PLAN AND ZONING COMMISSION

REPORT TO PLAN AND ZONING COMMISSION Meeting Date – October 4, 2016

REQUESTED ACTION: A conditional use to permit establishment of a 12,660 SF “shopping center” in the Commercial Core area of Mahomet on a ~32,600 SF parcel. The development as proposed is a conditional use in the C-2 General Commercial Zoning District.

OVERALL SITE PLAN
NEW RETAIL BUILDING
602 E. MAIN ST.
MAHOMET, ILLINOIS

OVERALL SITE PLAN
 NEW RETAIL BUILDING
 602 E. MAIN ST.
 MAHOMET, ILLINOIS

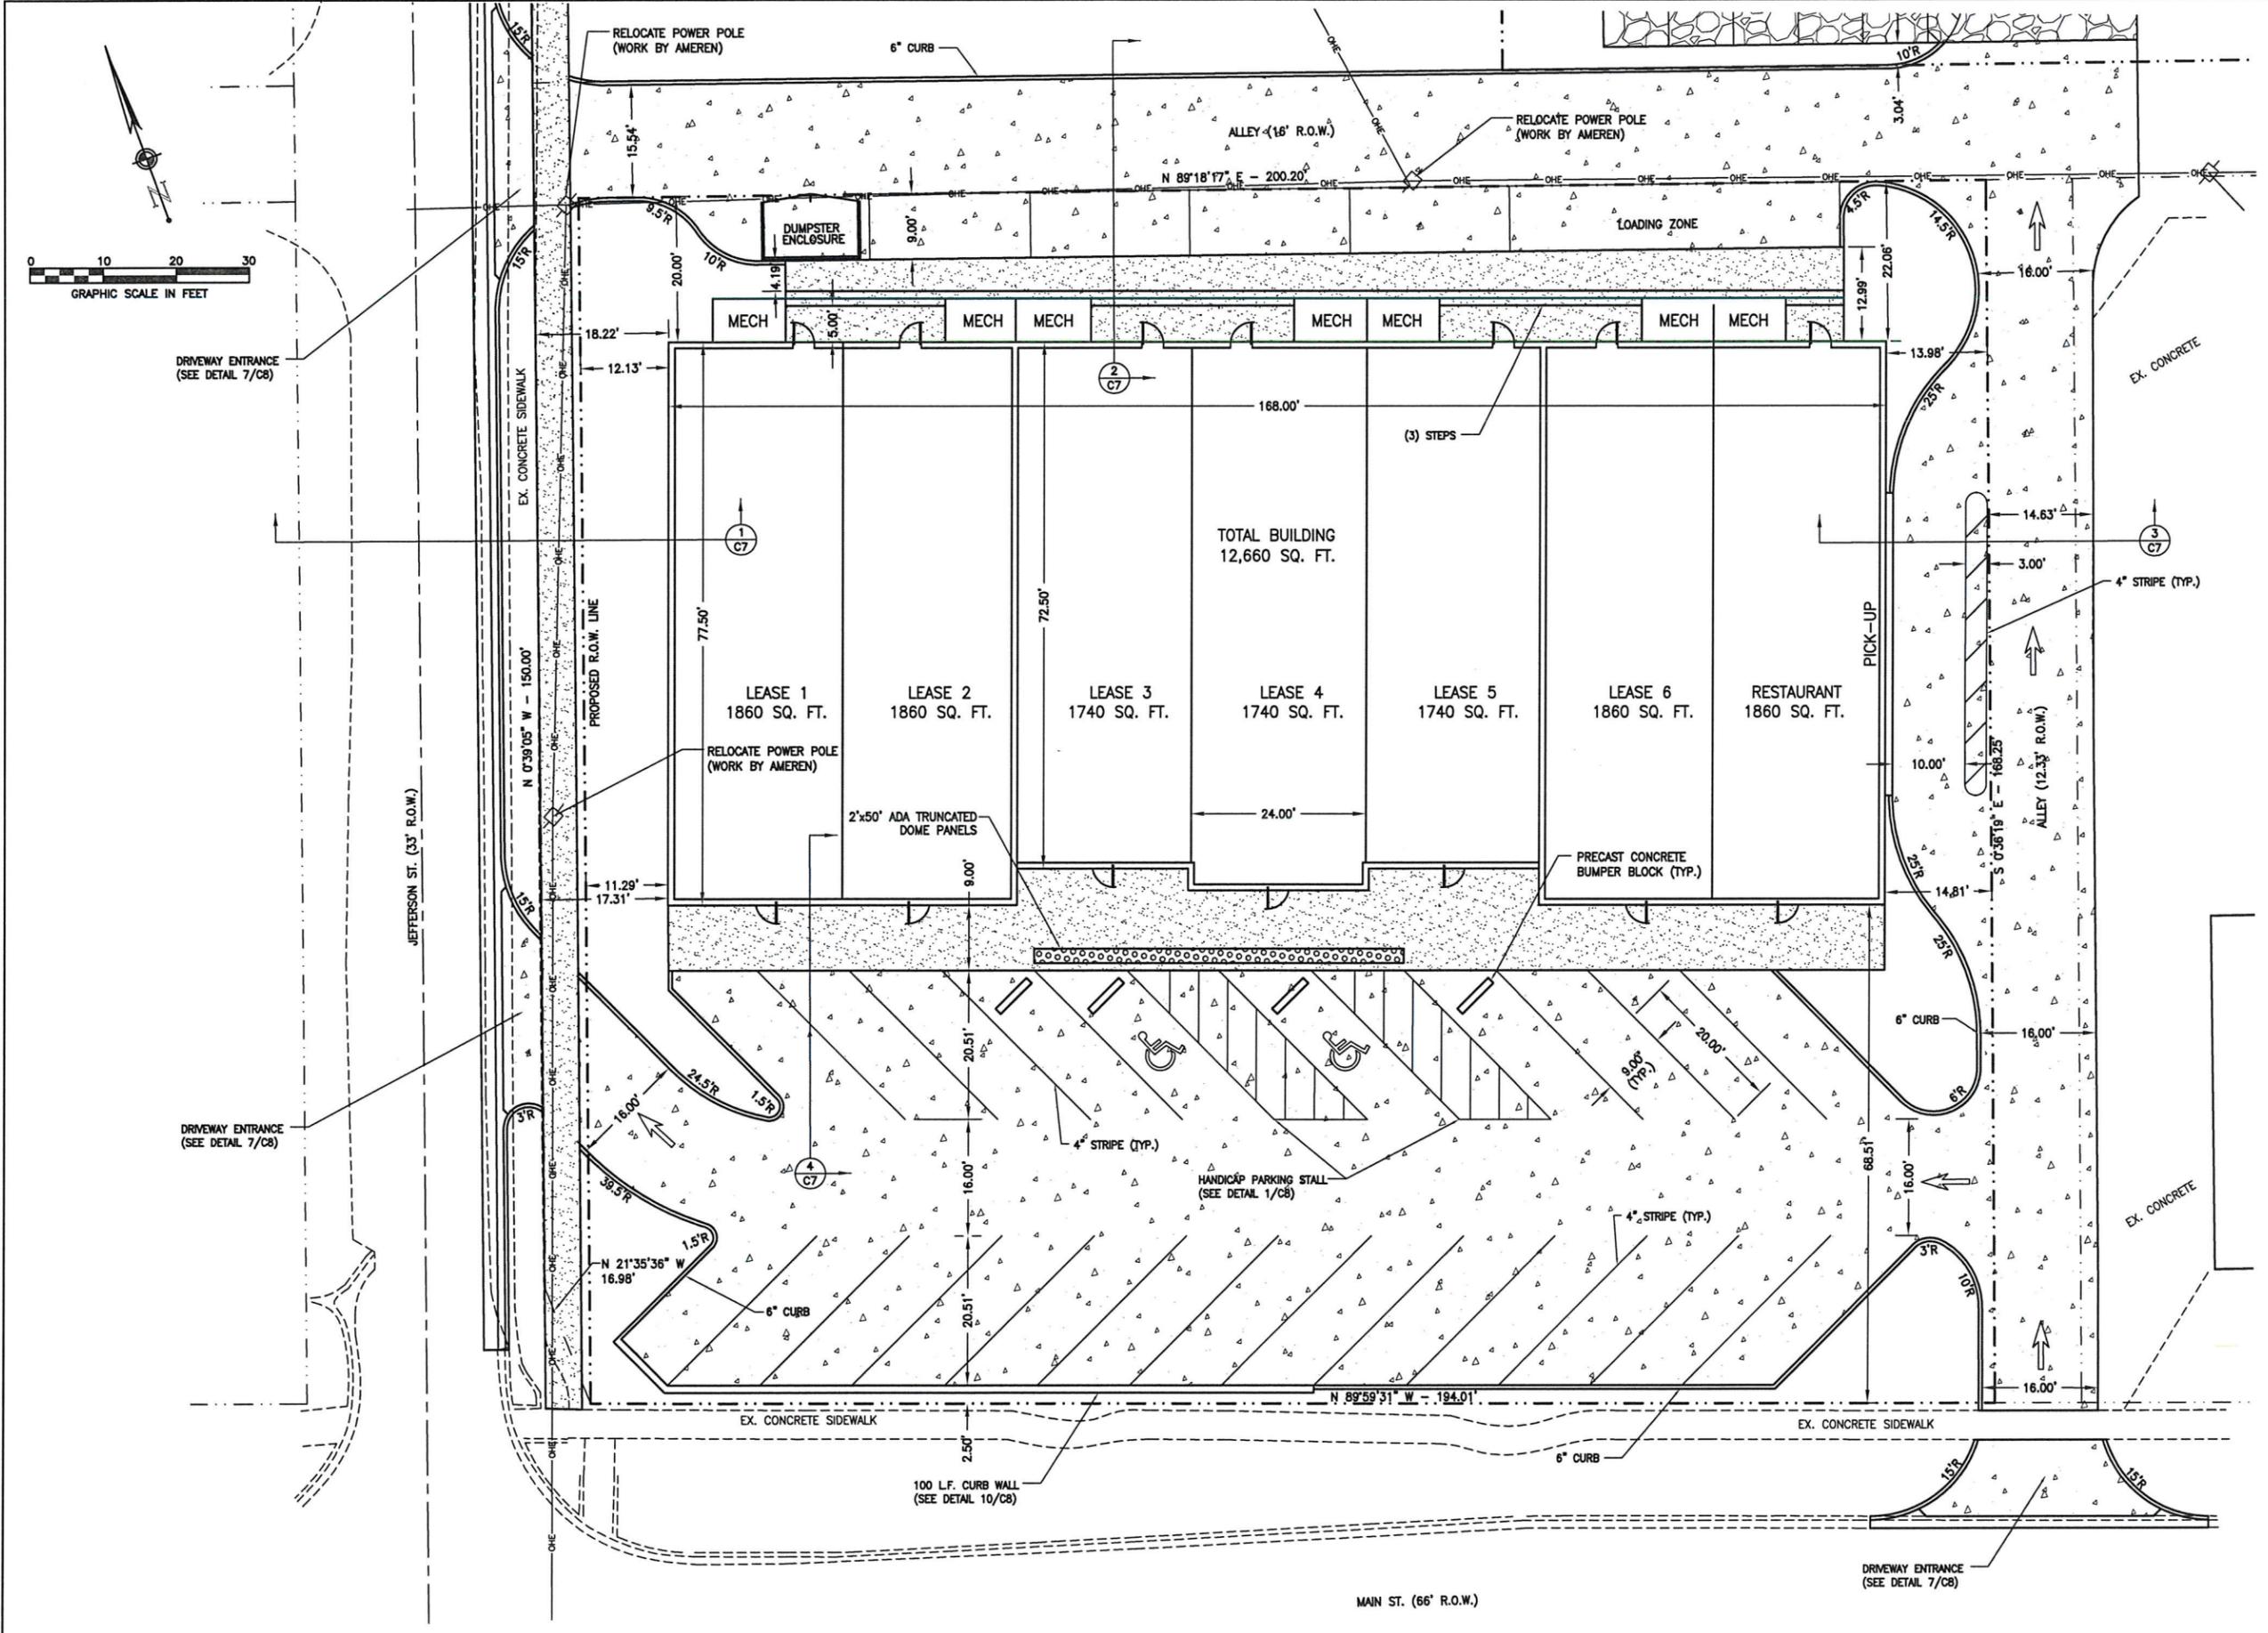
PROPERTY BOUNDARIES: The site plan indicates five (5) lots that will contain the proposed building; two (2) lots to the north/northeast that will contain a parking lot; two alleys (one on the north and one on the east); and, a dedication of private property to increase the right-of-way of Jefferson Street. The 12,660 SF building will be contained on a site that is currently 32,600 SF. The property will “lose” approximately six (6) feet along the western side of the property which is an area of ~ 950 SF. The six (6) feet is proposed to be dedicated to the Village to allow the widening of the Jefferson Street pavement and installation of a five (5) foot sidewalk. The alleys are currently public right-of-ways. The site plan proposes those as circulation around the building versus access to the site. The alley on the north side of the site is not currently paved – it is grass covered. The existing alley cannot serve the MAYC property due to the elevation difference between the alley and the MAYC property. The alley on the east side of the property is 12 feet wide and currently rock. The development proposal indicates the surface may be widened by a couple of feet.

Staff Comment: Staff will be recommending that the Board of Trustees vacate both alleys. The land area will transfer in some manner to adjacent land(s). At a minimum, if the full width of both alleys are not transferred to the development site, easements will be necessary to enable improvements to and the use of the vacated alleys by this development in a manner consistent with the site plan. The basis for the recommendation is primarily that there is no longer a requirement to retain public alleys for the benefit of multiple lots. Functionally, the MAYC site cannot access the alley due to elevation differences. Redevelopment is challenging and vacation would

PARKING: The site development plan indicates a building of 12,660 SF is proposed. This size building would require 43 spaces which is 1 space for every 300 GSF. The site plan indicates the project meets this requirement with the addition of off-site / overflow parking to be located on two (2) currently vacant lots north of the property. The site plan shows 23 spaces in the front of the building and four (4) parallel on the back of the building. Additionally, the off-site lot shows 16 spaces for a total of 43 spaces. Commercial properties can include offsite parking within 300 feet of the site as a means of meeting the parking requirements provided there is an instrument recorded that secures the use/facility.

The site plan indicates that the front parking lot is proposed to be one-way only flowing westerly, which is fundamental functioning of an angled lot. Per discussions with staff, the exit would be structured to force right only turns onto Jefferson Street. The proximity to the Main / Jefferson intersection was the concern that led to this restriction.

The site plan indicates that the alley on the east side of the property is one way northbound. The width of the pavement is unclear. It would serve only as an entrance to the site (and to Taffie's). This alley would be the only way to enter and obtain access to the proposed pick-up window. The pick-up window is a "pull off" separated by a median of some sort from the alley.

The site plan includes off-site parking. A lot with head in parking is proposed, it would have one entrance and exit which is generally off the intersection of the existing two alleys. Exiting the lot would be limited to right turn only and all traffic would go to Jefferson.

1. **Width of travel lane.** The width of the pavement is a concern. The north / south alley ROW is 12 feet wide. The site plan appears to pave a foot or two of the site to widen it. However, staff cannot determine where the pavement is in relation to the parcel. The final width proposed is 14.63 feet at its narrowest. New regulations would require an alley to be of pavement 20 feet wide but 16 feet is possible for the travel lane. It is two feet narrower than the width of two (2) parking spaces adjacent to each other but it is also the width of most alleys in the downtown area. The proposed is not a width that will allow vehicles to be able to pass.
2. **Width of the entrance/exit area at Main.** The width of the driveway at the sidewalk and curb is a concern but they are proposing it to be wider than the 14.63 foot travel lane. The

- a. Jefferson St. ROW and pavement is constructed as shown on the plan sheet (attached) prior to occupancy.
- b. “Alley”/ circulation drives will accommodate two-way traffic
- c. The southern driveway exit onto Jefferson is constructed with a negative radius at the southern curb to prevent left turns - a modification of the attached site plan.

SECTION 1 JEFFERSON STREET

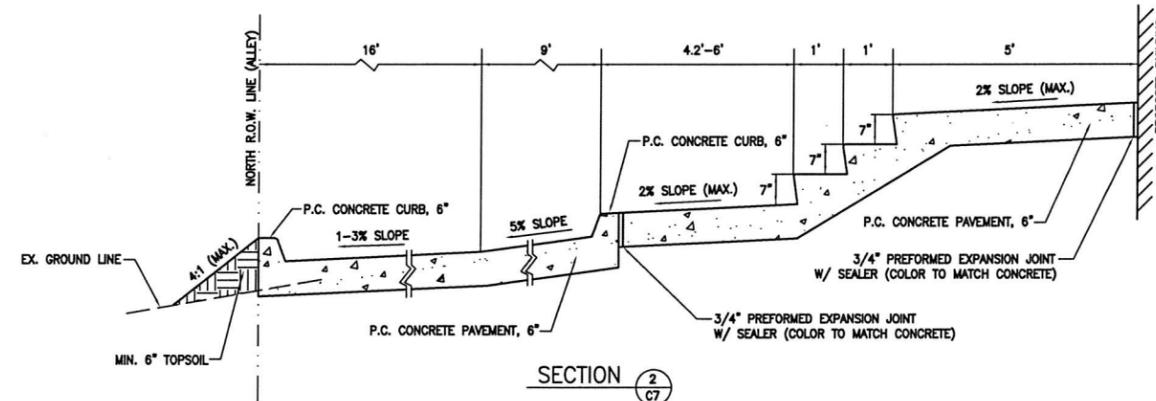
The subdivision ordinance requires only half-street roadway improvements adjacent to land subdividing. Any full width improvements would be half funded by the Village. The Jefferson Street right-of-way in this area is only 33 feet wide and the Township building has a zero setback from the ROW. Under no circumstances can Jefferson Street be improved to meet current standards. The pavement grades on Jefferson Street also present challenges. The developer discussed Jefferson Street conditions and options with staff many times to determine reasonable solutions. The submitted plans are of the form that staff will recommend to the BOT.
